1638C AND 1639D TELEPHONE SETS

1.001 This addendum supplements Section 502-611-404, Issue 1.

Fig. 1—1638C (MD) and 1639D (MD) Telephone Set, Connections

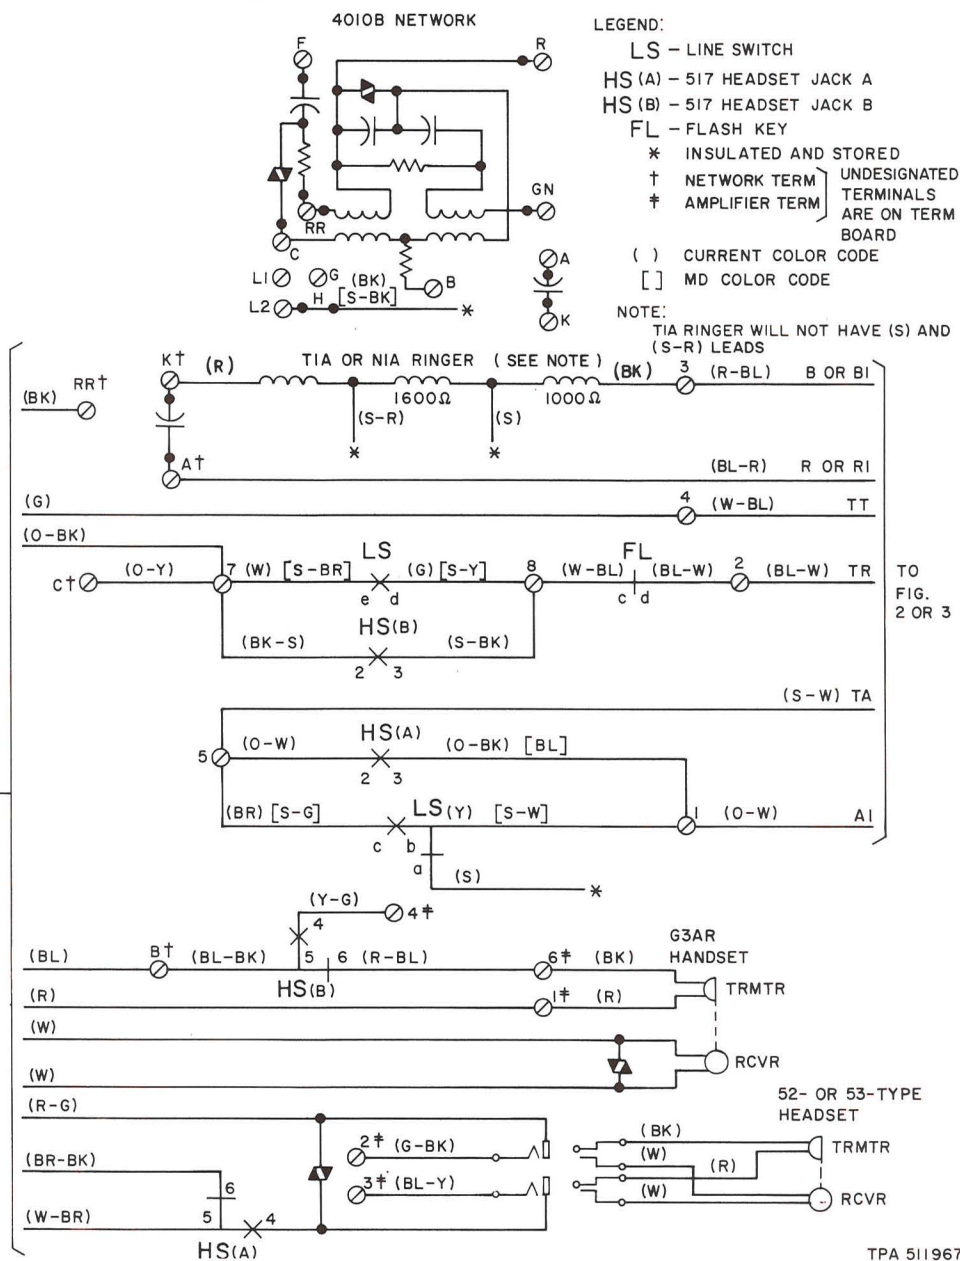
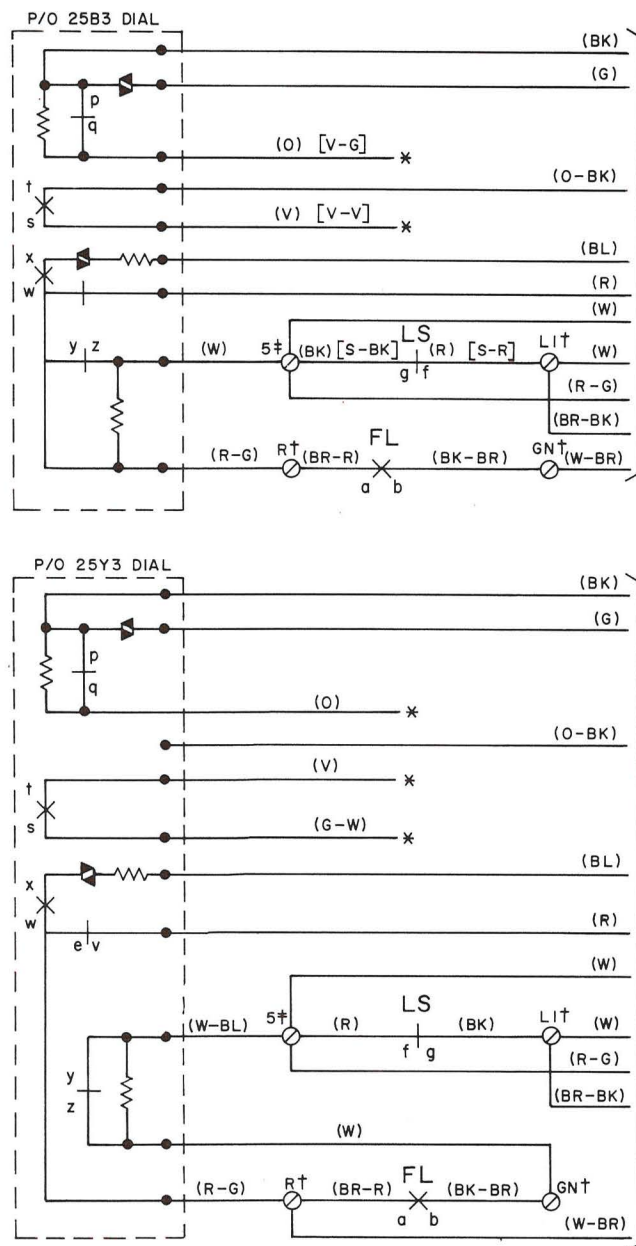
- (a) 2.08—Added
- (b) Table A—Revised
- (c) Fig. 1—Revised

2.08 1638C and 1639D telephone sets may be equipped with 241A (MD) or 241B amplifier. Connections for both amplifiers are the same.
